## Application for Works Approval

<b>Works Approval Number</b>	W6544/2021/1
<b>Applicant</b>	Mortlock Malt
<b>File number</b>	DER2021/000218
<b>Premises</b>	Mortlock Malt 6013 Northam-Pithara Road KARRANADGIN WA 6460  Legal description Lot 81 on Deposited Plan 68682 Certificate of Title Volume 2773 Folio 699
<b>Date of report</b>	11/10/2021
<b>Decision</b>	Works approval granted

## 3. Evaporation pond design review

**Figure 1 Mortlock Malt works approval application pond design**

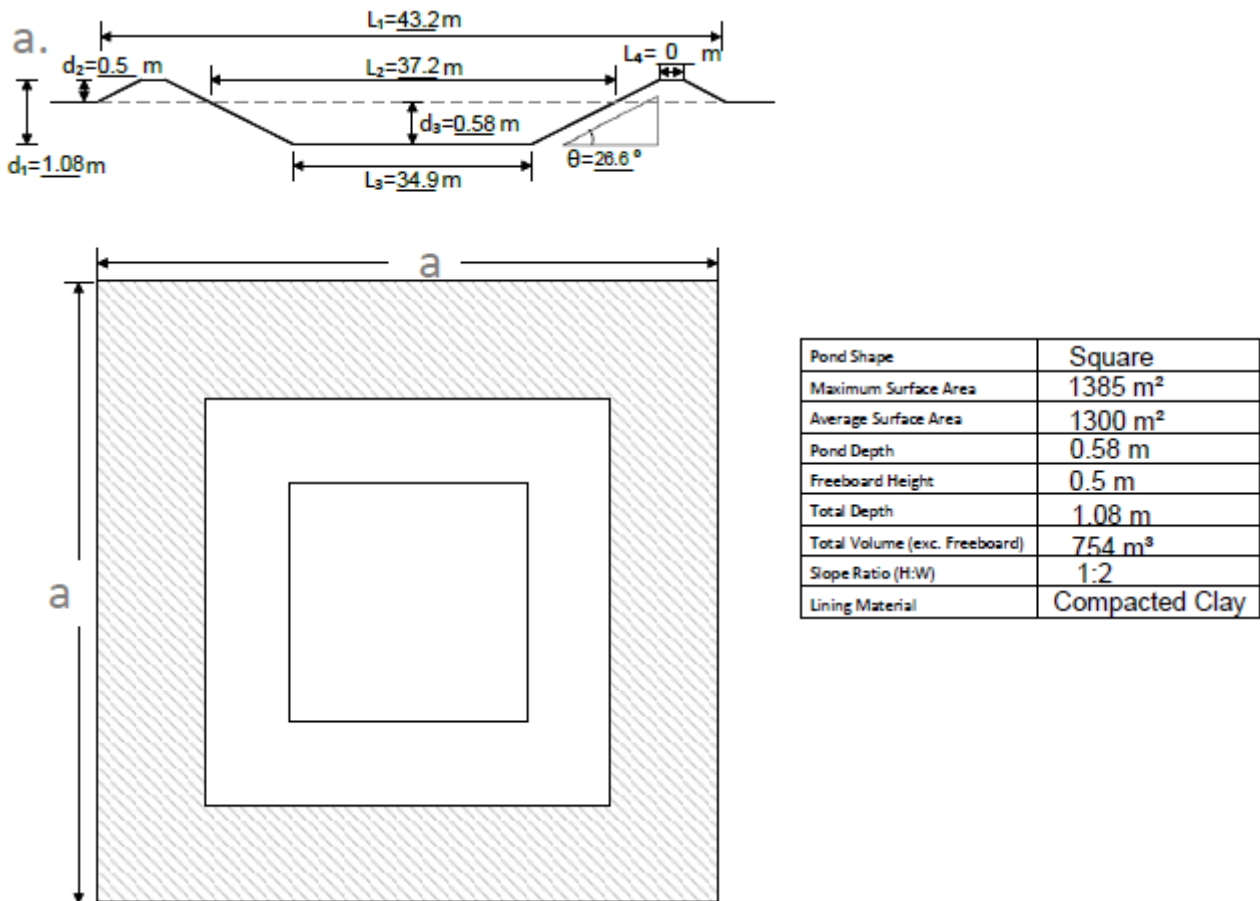
DWER received advice regarding the design, construction and siting of the evaporation pond from the Department of Primary Industries and Regional Development (DPIRD) on 6 July 2021. DPIRD advised that based on the proposed depth of the evaporation pond and the depth of the local groundwater profile, the evaporation pond would achieve the minimum distance requirement of two metres between the base of the evaporation pond and the groundwater profile, as per the requirements contained in *Water Quality Protection Note 27 Liners for containing pollutants, using engineered soils* (WQPN 27).

DPIRD advised that the use of local clay soils to line the evaporation pond would be compliant with the requirements of WQPN 27. DPIRD advised the department that soil-based liners should comprise natural in-situ low-permeability soils which have been grubbed to remove stones and plant roots, ripped, and watered to achieve the optimum moisture content. These clay liner soils also need to be compacted then rolled to achieve the final containment structure. DPIRD advised that the soil testing undertaken for the local clay soil profile by the applicant determined that a permeability of  $1 \times 10^{-9}$  metres per second can be achieved. Therefore, DPIRD expects the clay soil-based liners constructed on the evaporation pond to achieve an acceptable level of permeability.

The Delegated Officer identified no notable issues with the applicant's water balance model and considers its inputs are appropriate in the context of this application. The Delegated Officer agrees with the outcomes of the applicant's water balance model but notes it did not include inflow from the surrounding catchments into its calculations, despite the proposed location in a natural depression. The applicant has proposed above ground embankments to prevent inflow from the surrounding catchment.

The Delegated Officer agrees with the applicant and DPIRD's view that the clay soils at the premises can form the basis of a competent clay liner which will inhibit the seepage of nutrient rich wastewater from the evaporation pond. The Delegated Officer notes the applicant has not proposed any construction or quality assurance measures to confirm the constructed clay liner achieves the proposed permeability.

The Delegated Officer has therefore conditioned the works approval to include minimum source material criteria and clay liner construction specifications together with completion of QA/QC tests to ensure the clay liner has achieved the necessary efficacy, prior to use. The QA/QC tests are consistent with those contained in the <i>South Australian Environmental Protection Authority Wastewater Lagoon Construction guidelines</i> , due to the high standard of the testing procedures contained in this guideline and their applicability to wastewater ponds utilised in agricultural settings. The Delegated Officer noted that the applicant proposed to remove solid build up from the pond on an as-needed basis. As solids removal activities have the potential to impact liner integrity (which could lead to leakage through the pond liner) the Delegated Officer has included an operational requirement that sediment removal campaigns are undertaken in a manner which maintains the integrity of the evaporation pond liner. Additionally, the sediments are likely to contain elevated nutrients which could leach out when disposed or stored therefore the Delegated Officer has specified the sediments are not to be
